RESPONSE TO NRC CONCERN WITH TEMPERATURE EFFECTS ON SAFETY-RELATED ELECTRONICS IN MAIN CONTROL ROOM

In a recent NRC Inspection Exit Meeting and USNRC Inspection Report 05000458/2015010, Attachment 3, a concern was expressed by the NRC that the evaluation of the Loss of HVAC in the Main Control Room does not appear to be conservative with respect to the potential impact on safety-related electronic components. Two documents were cited as a basis for this concern:

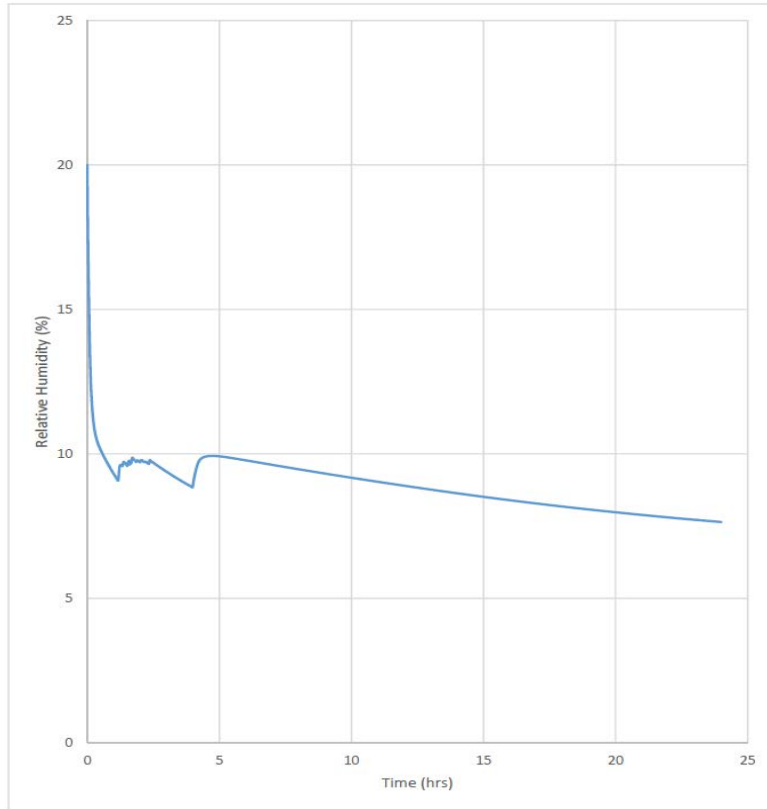
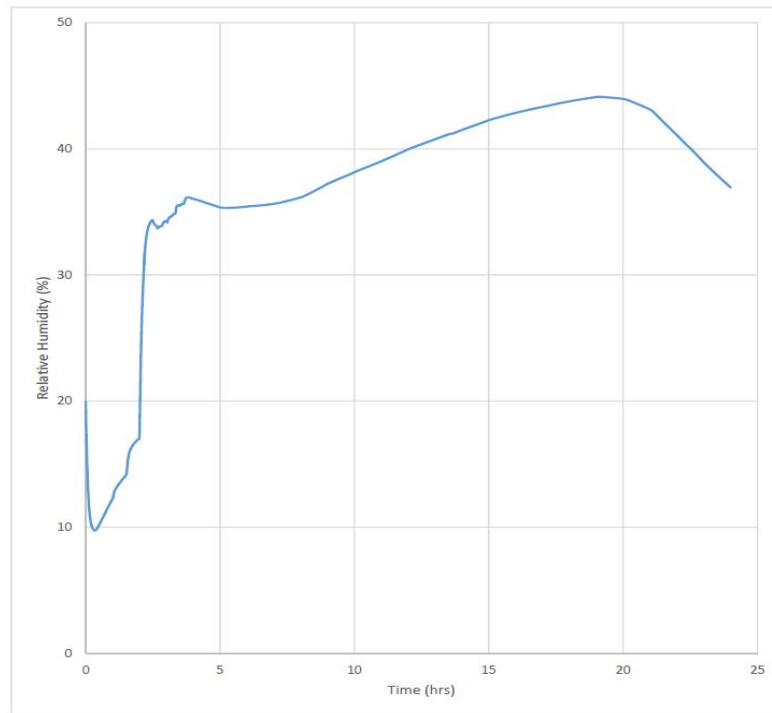
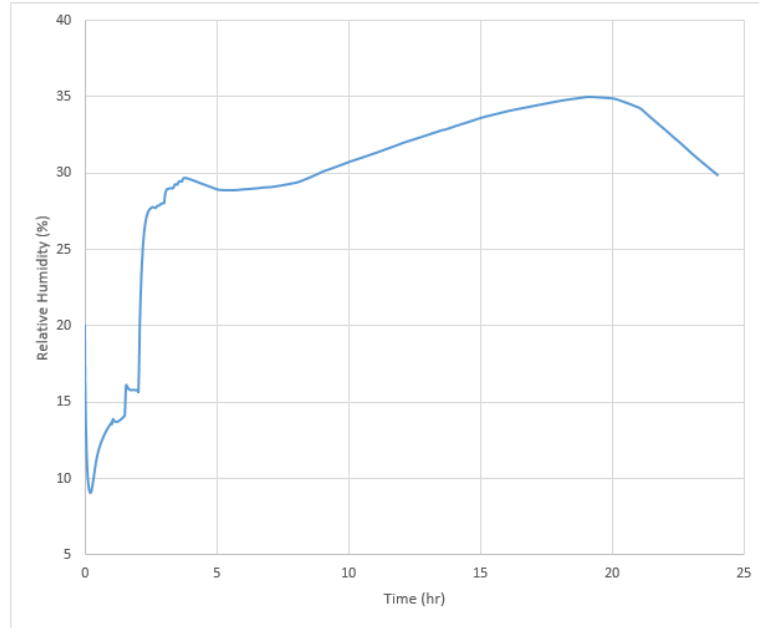
Accounting for all inputs, the NRC considered that the licensee’s posture of ensuring the control room was maintained less than 120°F would only be acceptable for scenarios which would only result in elevated temperatures up to four hours and only if they also demonstrated that humidity did not rise appreciably in those four hours.”

The control room equipment is designed for a maximum temperature of 122°F. The GOTHIC model (Reference 5) shows that ambient air temperatures will not exceed the equipment design maximum temperature of 122°F. Additionally, Figures 3, 6, 7, and 9 show that humidity will remain low and within the Main Control Room's Environmental Design Criteria. Therefore, the 4-hour limit is not applicable to River Bend Station Main Control Room.

Figure 7: Maximum Local Relative Humidity (Just Inside MCR Door)

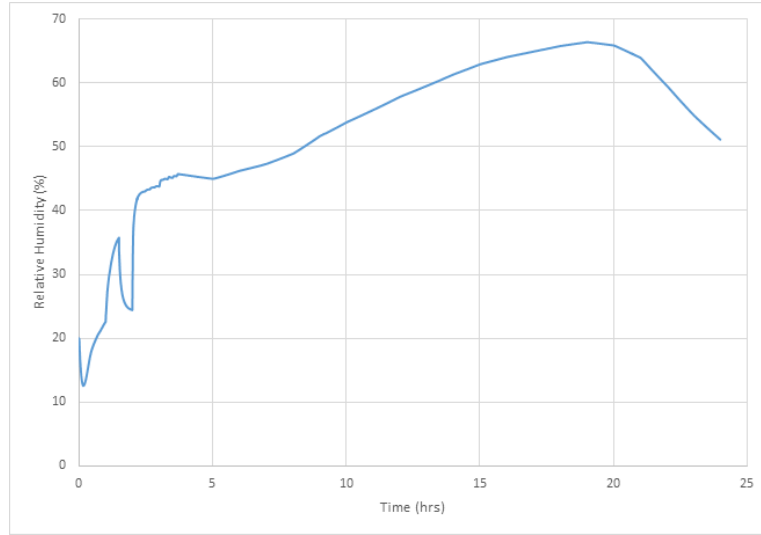
Concerning the synergistic, or combined, effect of high temperature and high humidity, the GOTHIC model (Reference 5) shows that temperature will not exceed 122°F. The highest cell/subvolume temperature for the cases considered is 121.8°F in subvolume 187 at 2.02 hours into the event. Subvolume 187 contains panel H13-P630 which is a non-safety related annunciator logic cabinet. Relative humidity is expected to be ~65% RH (in the subvolume around the Main Control Room door into the southwest stairwell), which is not high and within the maximum relative humidity of 70% specified in the River Bend Environmental Design Criteria for the Main Control Room.

Because humidity is not expected to be high (~65% RH per Figure 7) and temperature alone appears to have “insignificant” risk effects, any risk to microprocessor based safety-related equipment is low. Therefore, the NRC’s reference to NUREG/CR-6479 does not identify any previously unevaluated risk factors to electronic equipment during the loss of Main Control Room cooling event at River Bend Station.

Figure 8: Temperature in Subvolume 171 for Case 2

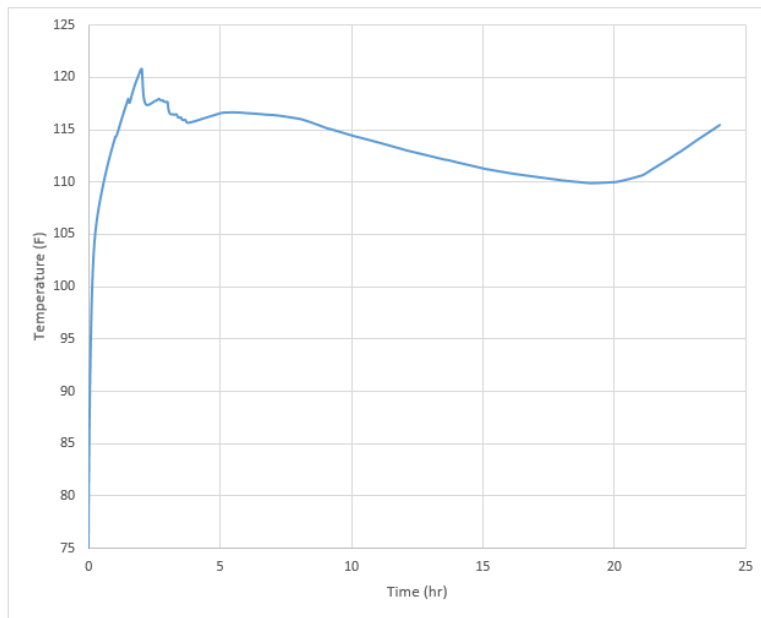
The subvolume with the highest temperature (120.8°F) that contains safety related equipment is subvolume 171 surrounding panel H13-P694, Reactor Protection System Logic Div D (Figure 8). The peak temperature occurs 2.02 hours following the start of the event; for less than 11 minutes of the entire 24-hour event, subvolume 171 has a temperature above 120°F. For the remainder of the event, subvolume 171 experiences temperatures below 120°F.

With average Main Control Room temperatures never exceeding 116.1°F, maximum local cell/subvolume temperatures never exceeding 120.8°F for safety related electronic equipment, and the Main Control Room back panel doors all being opened, the design temperature of the safety-related electronic equipment is reasonably assured to not be exceeded. Additionally, considering the information presented in the Farley Response to NFPA-805 RAI (Reference 10), WCAP 8687 accelerated thermal aging tests shows electrical/electronic equipment can survive up to a year at elevated ambient temperatures up to 185°F.
